Title QPD LCD Readout			LIGO Project California Institute of Technology Massachusetts Institute of Technology		LIGO [®]	
Size: B	DCC Number: D1102092	SCH / PCB Revision: V3	Engineer: S. Abbott	Date: 9/25/2012		
File: C:\Rich's Files\Mycadfiles\ISC\QPD\QPD Calibrator\QPD LCD Readout V3\QPD LCD Readout V3.SchDoc				Time: 11:25:27 AM		
				Sheet * of *

QPD LCD Readout
aLIGO D1102092-v3

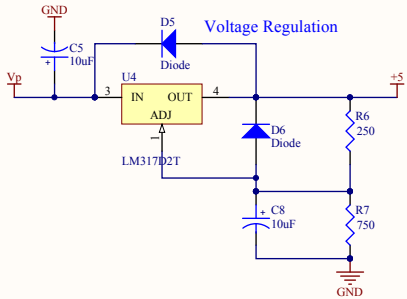
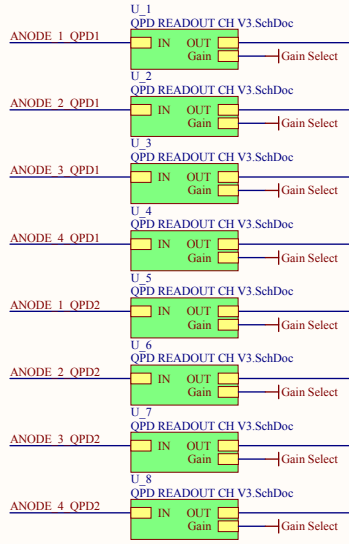
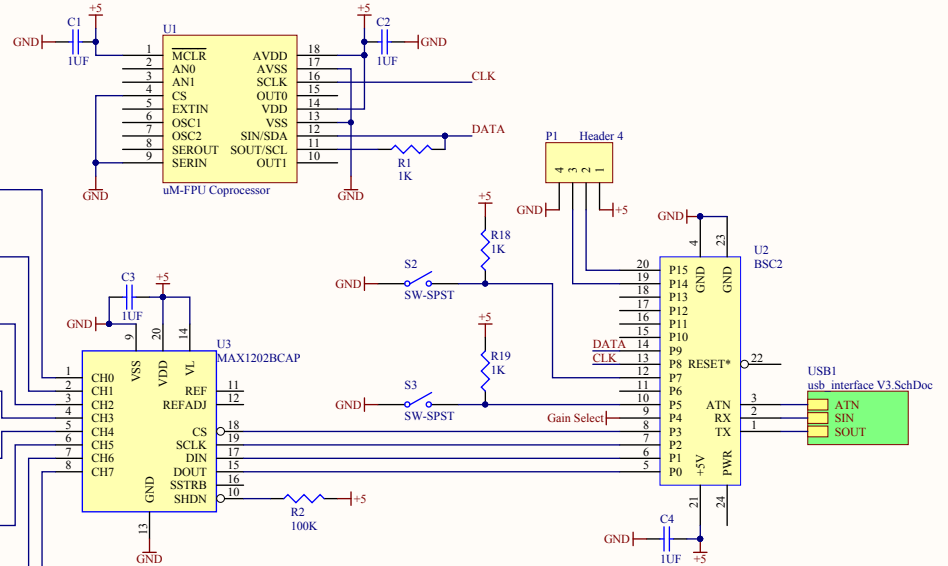
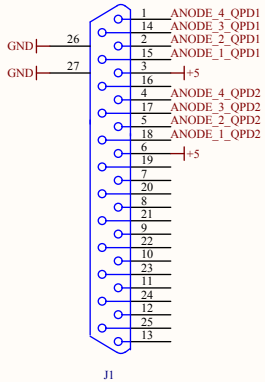
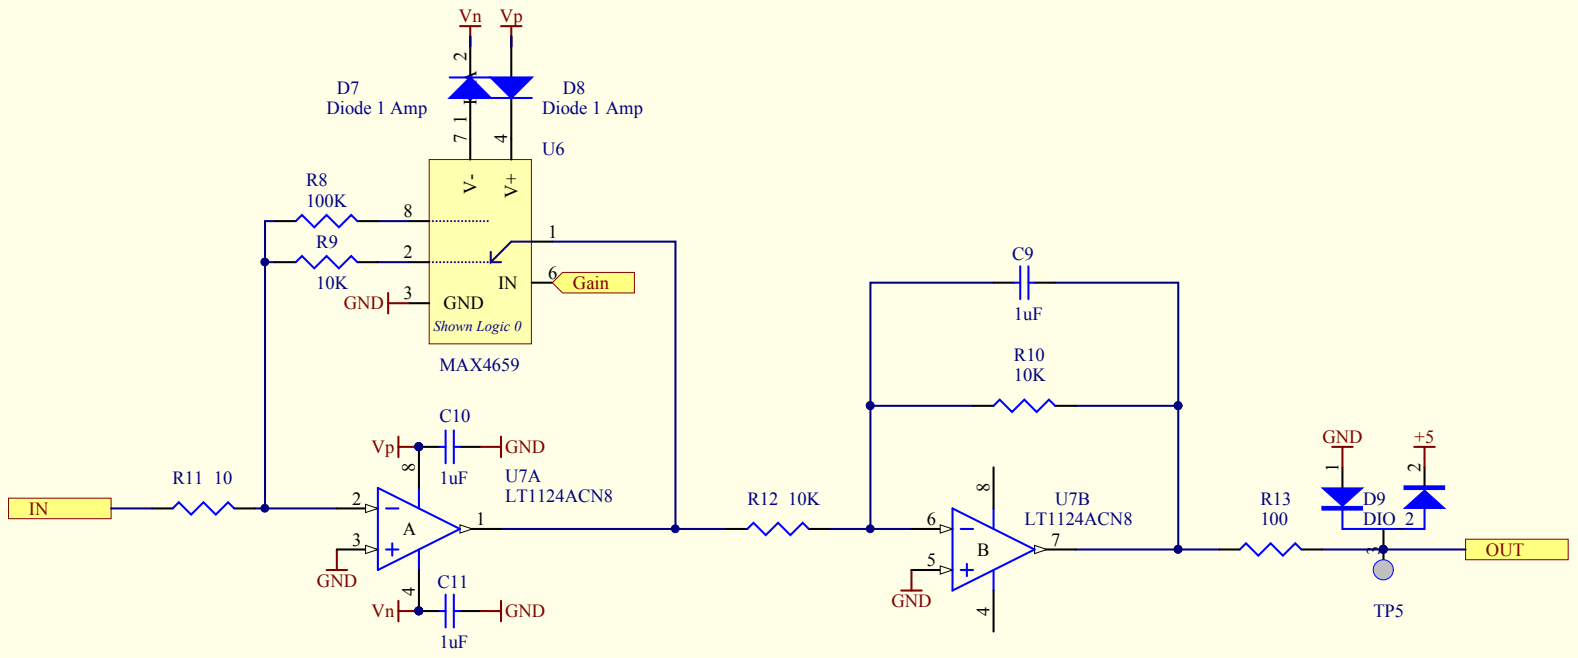
The +5V for J1 is supposed to be connected to pin 16 and 19, not pin 3 and 6. There is no harm in units having power on pins 3 and 6, so an easy fix is to short 3 to 16, and 6 to 19. This restores bias to the PD under test, without which the unit won't work.

Title			* * *		
QPD Readout USB Interface					
Size: A	DCC Number: D1102092	SCH / PCB Revision: V3	Engineer:	Date: 9/25/2012	
File: C:\Rich's Files\Mycadfiles\ISC\QPD\QPD Calibrator\QPD LCD Readout V3\usb interface V3.SchDoc				Time: 11:25:27 AM	Sheet * of *

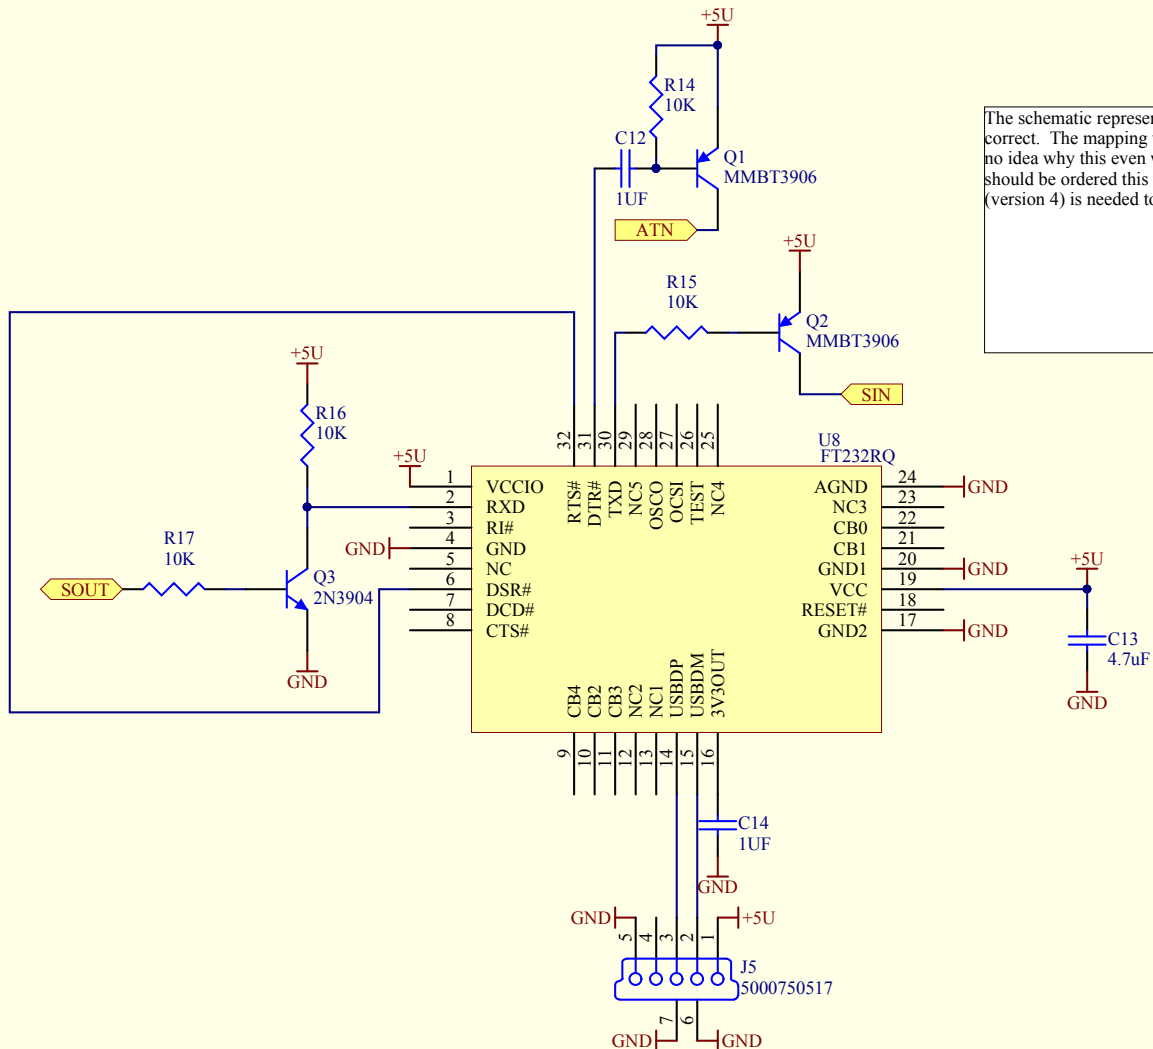
On the USB interface page, the schematic representation of Q1, Q2, and Q3 are correct. The mapping to the footprint is not. I have no idea why this even works, but no more boards should be ordered this way. A new revision (version 4) is needed to correct this footprint error

The schematic representation of Q1, Q2, and Q3 are correct. The mapping to the footprint is not. I have no idea why this even works, but no more boards should be ordered this way. A new revision (version 4) is needed to correct this footprint error
